# Wollongong Local Planning Panel Assessment Report | 2 May 2024

<b>WLPP No.</b>	Item No. 2
<b>DA No.</b>	DA-2022/1010
<b>Proposal</b>	Residential - demolition of existing dwelling, tree removal, construction of dwelling, swimming pool and associated landscape works including retaining walls
<b>Property</b>	127 Lawrence Hargrave Drive AUSTINMER NSW 2515
<b>Applicant</b>	Rebecca Goodman Town Planning Pty Ltd
<b>Responsible Team</b>	Development Assessment & Certification Team - City Wide Team (BM)

## ADDENDUM REPORT

Drawing Title  
**PLAN - DEMOLITION**

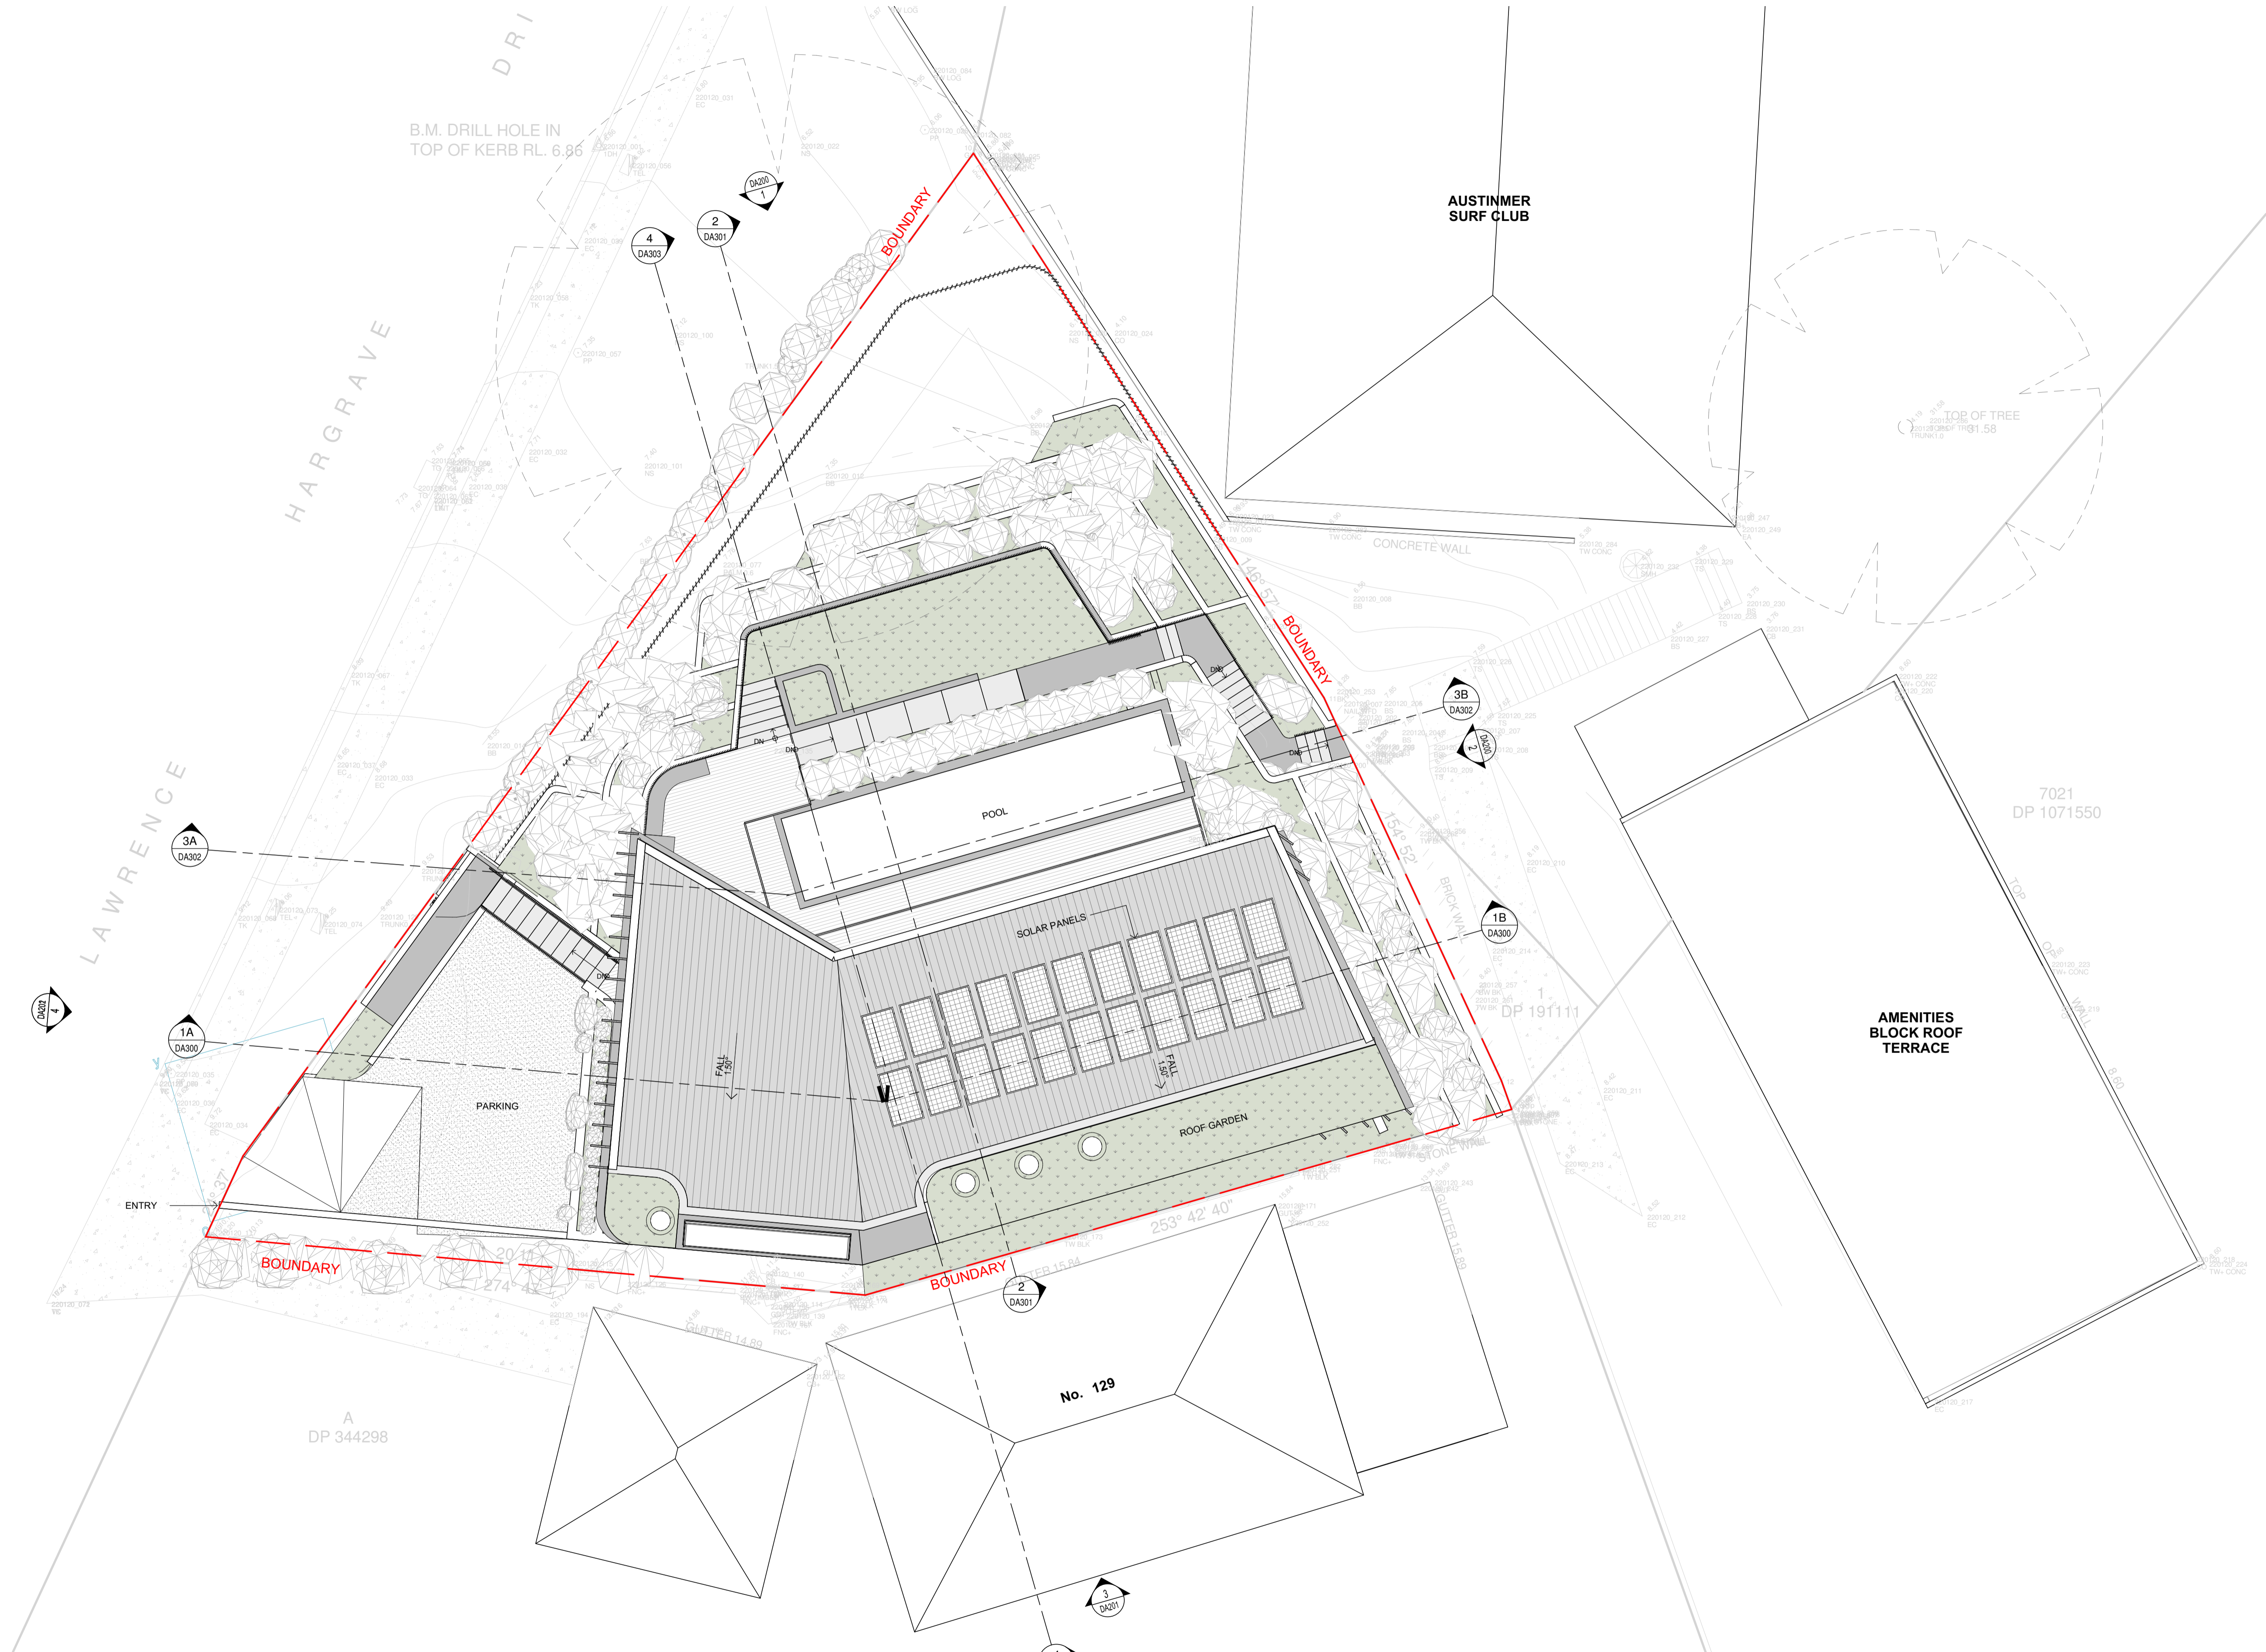
Amended Plans show (Demolition Plan – DA004 Issue B) the outer retaining walls and steps adjacent to the site boundary to be demolished. A Condition of Consent is also added regarding the licence agreement to be in place.

retaining wall, concrete steps and landing as shown in Demolition Plan DA-004 dated 16.01.24 revision B prepared by Sherson Architecture.

F4-1.8m Boundary Fence Typical Detail  
Scale 1:20 @ A3

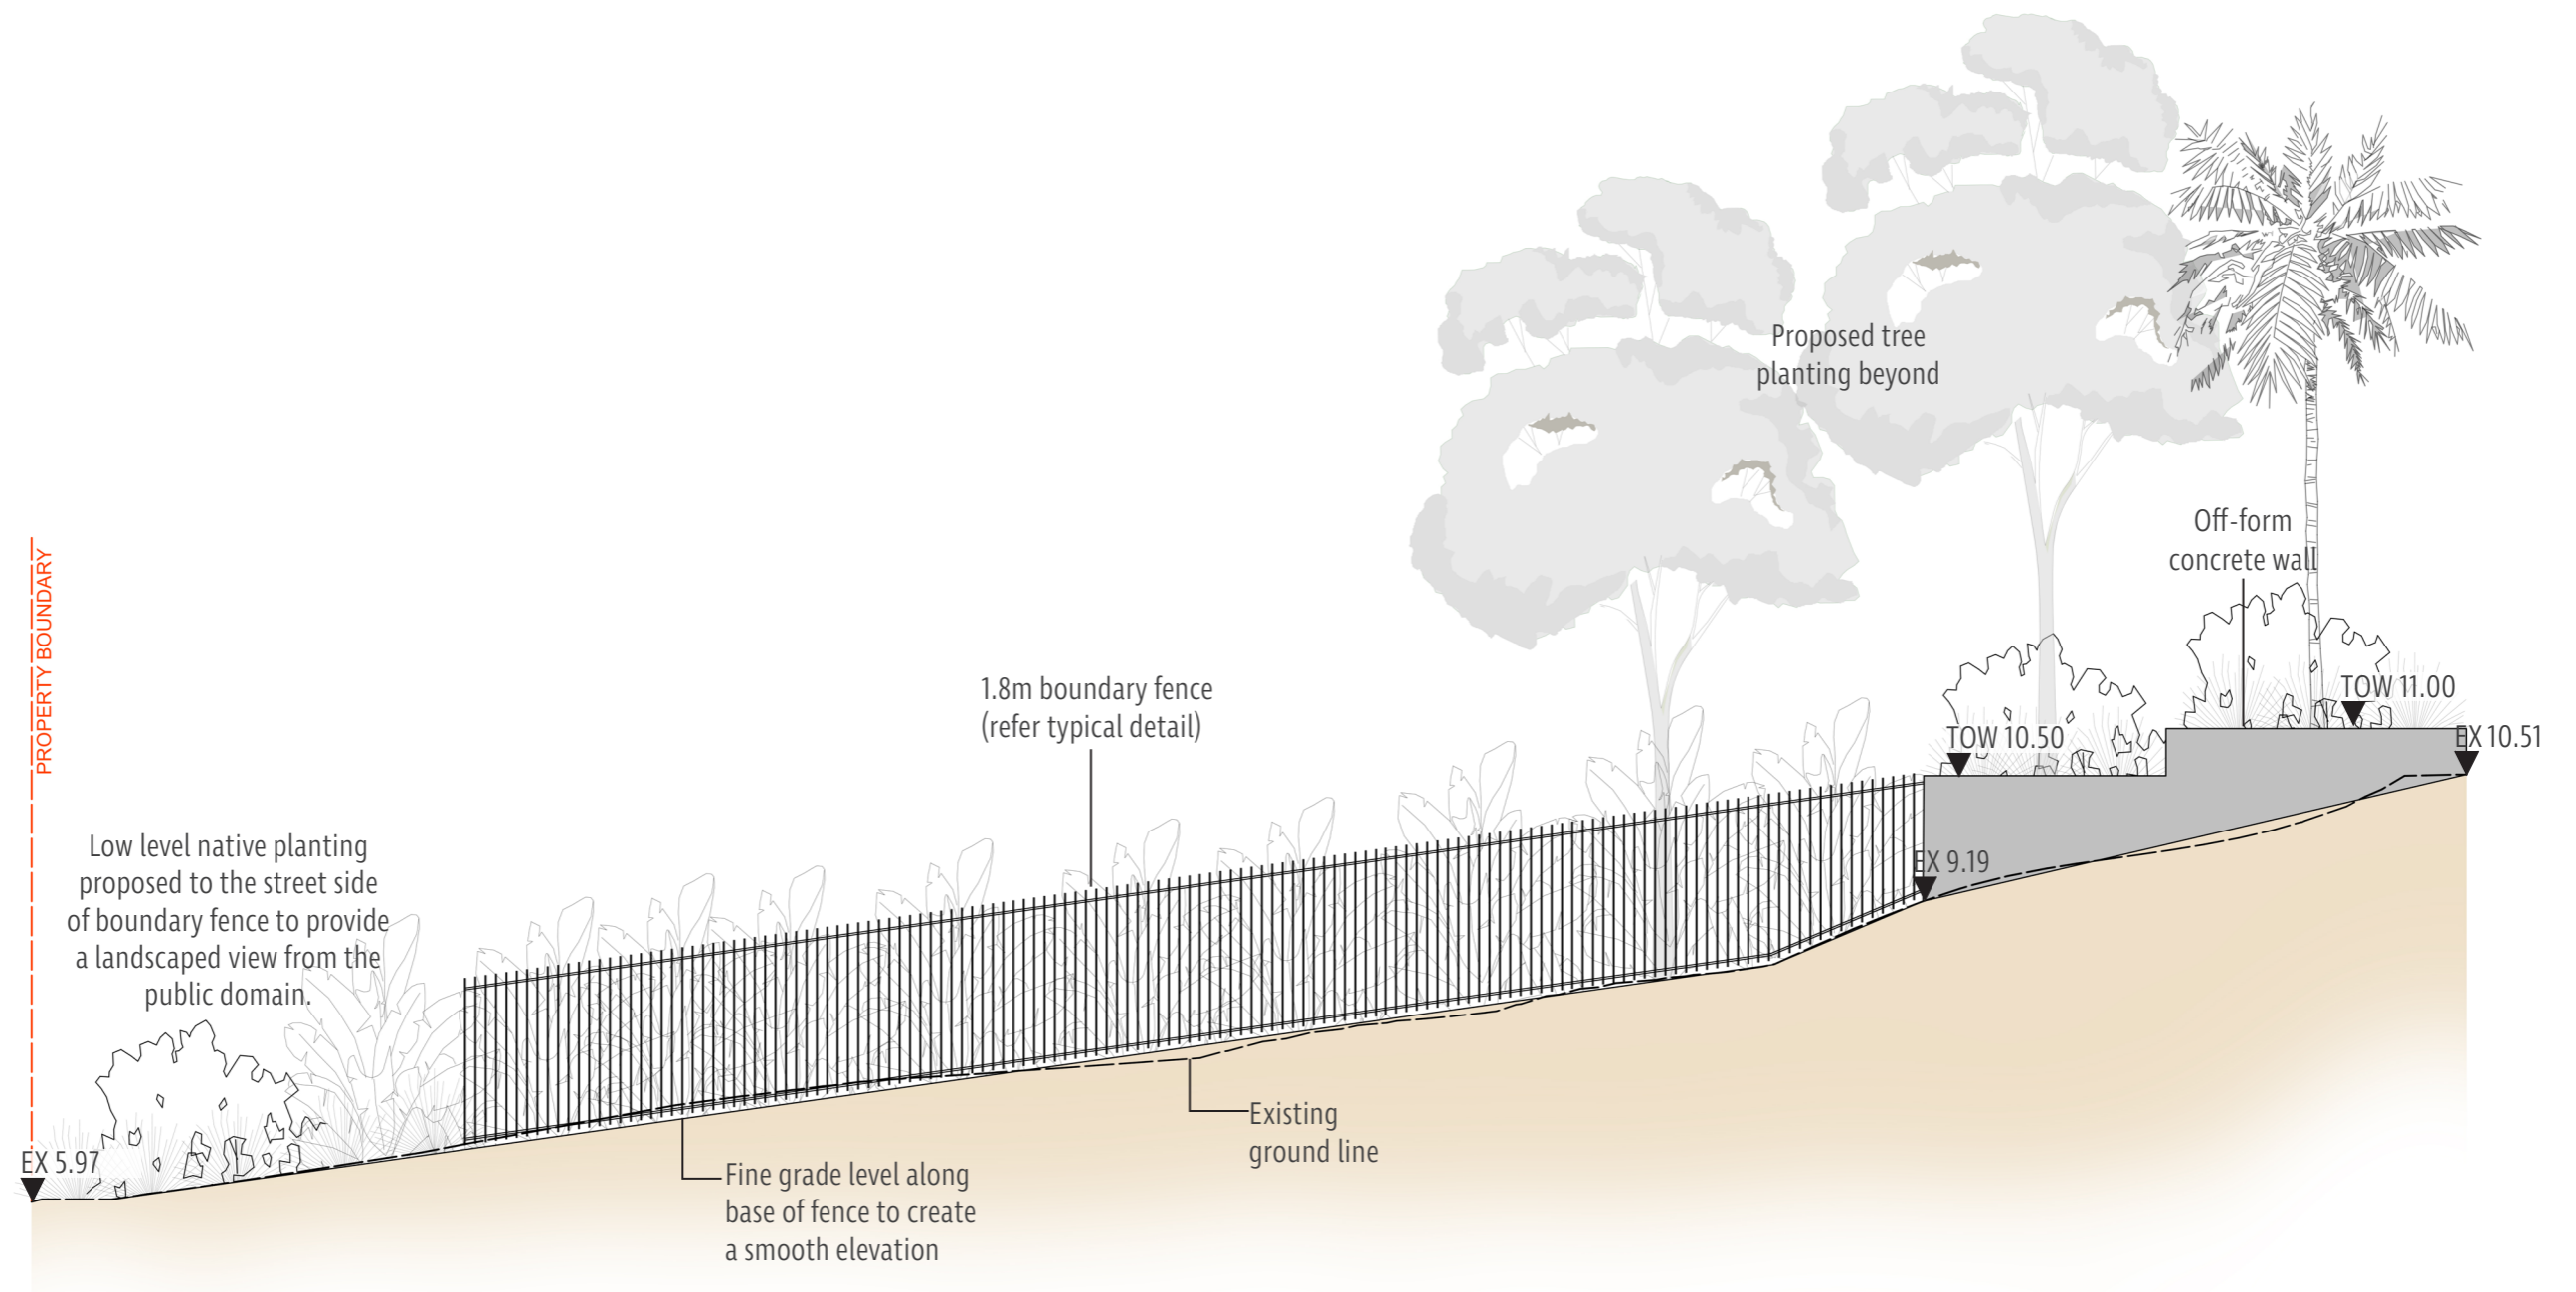
- ii *Details of all fencing along boundaries and the construction methodology of the fence along the western and northern boundary and retaining walls under the canopy of T3. The construction methodology is to be reviewed and agreed to by the arborist. Additional cross-sections showing the relationship of retaining walls, fences and landscape treatment to T3 are to be provided.*

The updated Landscape Plan details the 1.8m high black, palisade fencing along the western and northern boundaries. The updated Landscape and Architectural Plans also detail sections relating to fencing, retaining walls and landscape treatment beneath the tree canopy. The Arborist Report outlines details of construction methodology for Fencing and addresses impacts of development within the TPZ of T3.
